THE PUBLIC SERVICE COMMISSION OF SOUTH CAROLINA

DOCKET NOS. 2019-224-E and 2019-225-E

COMMENTS OF SCCCL, SACE, UPSTATE FOREVER, NRDC, SIERRA CLUB AND CCEBA IN RESPONSE TO MODIFIED 2020 IRPs

Figure 1 - Portfolio C1 Solar Capacity Additions by Category

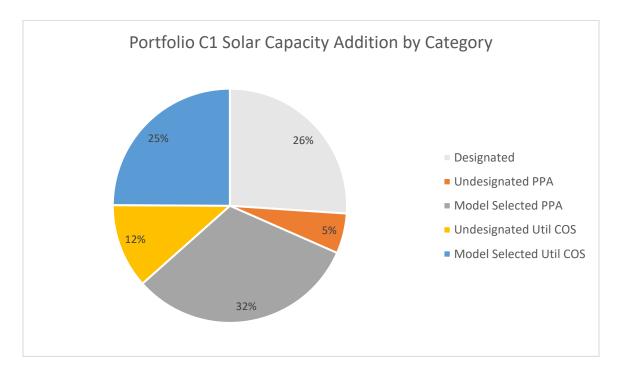
More than one-third of the solar capacity additions in Portfolio C1 were placed outside the ownership optimization routine as shown by the blue and yellow segments in Figure 1 below.³⁰

Duke's limits contradict the Commission's order to model third-party PPAs as a resource in determining a least-cost plan. So that the Commission understands and can evaluate a true least-cost plan on a level playing field, it should require Duke to remove any ownership requirement for "undesignated" resources and allow the model to select third-party PPAs when it is most economic to do so regardless of ownership share.
